XG-623 V1.1

802.11b/g Type IIIb Mini PCI

Atheros Communications, Inc. 520 Almaden Avenue Sunnyvale, CA 94085		XG-623 V1.1
Date: Monday, July 17, 2006	Rev: C	Rev: 000
Sheet: 1	of: 5	PWG NO: 245-01268-083

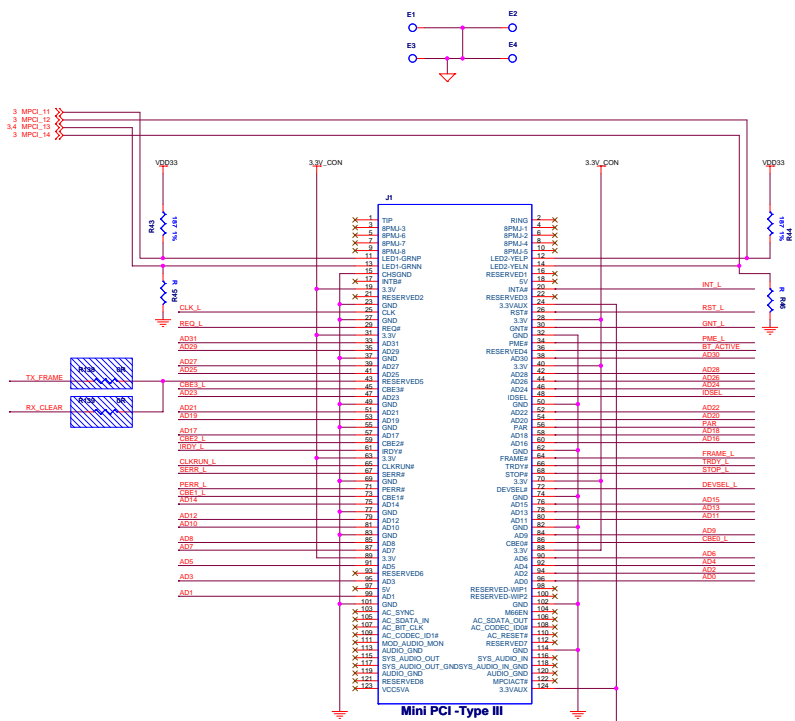
DATE	REVISION NUMBER	INITIALS	DESCRIPTION
1/8/04	245-01268-010, Rev 000	CL	Initial release
1/20/04	245-01268-011, Rev 000	CL	Change C22 from 10pF to 2.2nH (inductor). Change C24 from DNI to 1.5pF. Change C23 from 10pF to 0Ohm (resistor). Change C145 from DNI to 10pF. Change C77 from 18pF to 10pF. Change C75 from 100pF to 10pF. Change C76 from 220pF to 120pF. Change R128 from 47 to DNI. Change R129 from 47 to 0. Change R130 from 300 to 0. Change R31 from 100 to 22. Change C67 from 1000pF to 10pF. Change C70 from DNI to 1000pF. Change C71 from DNI to 10pF. Change C72 from DNI to 0.01uF. Change C73 from DNI to 1000pF
1/23/04	245-01268-012, Rev 000	CL	Change R2 from 0 to DNI. Change VR3 from DNI to AME8805MEFT
2/4/04	245-01268-013, Rev 000	CL	Change C74 from 2.7pF to 3.3pF. Change C41 from 1.5pF to 10pF. Change R52 from DNI to 1.1k. Change C38, C43, C44 from 2.7pF to 3.3pF. Change C26 from 2.2pF to 1.8pF.

2/17/04	245-01268-014, Rev 000	CL	Change C78 from 1.8pF to 10pF. Change L10 from 1.8nH to 3.3pF (capacitor). Change C42 from 1.5pF to 1.6nH (inductor). Change C29 from DNI to 1500Ohm (resistor). Change C24 from 1.5pF to 1500Ohm (resistor). Change C22 from 2.2nH to 390Ohm (resistor)
2/23/04	245-01268-020, Rev 000	JW	1) Change C22 to R131. Change C24 to R134. Change C29 to R133. Change C42 to L13. Change L10 to C147. Delete C23, C25. Add C148, 1uF, 0603 to input of VR3. Add RF Kill Circuit - R135 (0402, 07, 2N3906). 2) XLNA bias: Change C36, C39 from 0.1uF to 0.01uF. Change R54 from 62 to 82.5. Change R53 from 2.2k to 1.1k. Change R52 from 1.1k to 750 3) XLNA input match: Change C46 from 10pF to 5.6pF. Change C47 from 1pF to 1.5pF 4) XTAL: Change C9 from 24pF to 22pF. Change C10 from 10pF to 15pF
3/17/04	245-01268-030, Rev 000	CL	1) RF_IN Match: Change L13 from 1.6nH to C149 2.2pF. Change C147 from 3.3pF to DNI. Change C78 from 10pF to R137 0ohm 2) XPA Bias: Change R111 from 10 to 0. Change R31 from 22 to 0. Change R129 from 0 to 100. Change R130 from 0 to 150 3) XPA Supply: Change C77 from 10pF to 5.6pF. Change C76 from 10pF to 5.6pF. 4) 1.8V Regulator: Change Q2 from DNI to MMBT2907A. Change C140 from 4.7uF to DNI. Change VR3 from AME8805MEFT to DNI 5) RFOUT_BIAS: Change L6 supply from 3.3V_A to 1.8V_A. Change L7 supply from 3.3V_A to 1.8V_A 6) PME_L: Add R136 10K (0402) pullup 7) XLNA Bias: Change C39 from 0.01uF to DNI 8) XPA: Change U6 from LX5512B to GP1214

3/30/04	245-01268-031	CL	1) XLNA: Change C41 from 10pF 1% to 10pF 5% 2) RF_IN Match: Change C4 from 10pF to 1pF 3) Bypassing: Change C59 from 10pF to 2.2pF 4) External Detector: Change R81 and R84 from 1.1k to 5.1k 5) XPA Bias: Change R129 from 10 to 100 (again)
4/1/04	245-01268-032	CL	1) Mode Pins: Change R1, R3 from 10K 1% to 10K 5% 2) RF Kill: Change R67 from DNI to 10K 3) PME: Change R136 from 100K to DNI (10K)
4/6/04	245-01268-040	JW	Changed C6, C14 to 0402. Disconnect J1,p16. Delete R2 and sleep net. Swap U6 P8,P9. Remove R50. Remove Q6. Change R48 to R between 3.3V_AUX and GPIO_3. Change R49 to R between LED_1 and GND.
4/27/04	245-01268-050	JW	Changed R47 to 0805 package. Changed R131 to 22 ohms. Changed R133,R134 to 220 ohms. Changed R22 pin 2 from GND to 1.8V_A. Changed C8 to 10pF. Changed C27, C28,C38,C43,C44,C74 to 3.0pF.
4/27/04	245-01268-051	CL	Change R133, R134 from 220 5% to 221 1%. Changed C27, C28,C38,C43,C44,C74 to 3.0pF.

5/6/04	245-01268-052	CL	POR: Change R12,R13 from DNI to 10k. Change C1 from DNI to 0.1uF
5/28/04	245-01268-060	JW	Changed R12 to 0 ohm. Changed C1 to DNI. R12 is now connected to LED_1 instead of 3.3V.
6/4/04	245-01268-070	JW	Move C140 to 1.8V_A. Change R48 and R49 to DNI. Remove VR3,C57. Move C148 from 3.3V to 1.8V. Change Q2 to SOT89 CXT2907A. Changed Q5p1 to GPIO_5 and connected to U1pE2. Added R4, 0 OHM, to U1 pE1 and U3 p7. Added pullup R2, 10K OHM to U3 p7. Added R5 DNI between GND and U3 p7. Change R16 to 0603. Changed R13 to 1K. Disconnected U1pD3
6/9/04	245-01268-080	VN	Fixed pin out of Q2.
6/11/04	245-01268-081	CL	Excel BOM hand-edited. EPICOM PA added as Alternate Vendor. PCB part number up-rev'd as well as header and footer information.
7/6/04	245-01268-082	CL	Changed R130 from 150 to 200.
7/12/04	245-01268-083	CL	Add OEpic as alternate XPA following regulatory certification and ATMEL as alternate EEPROM.
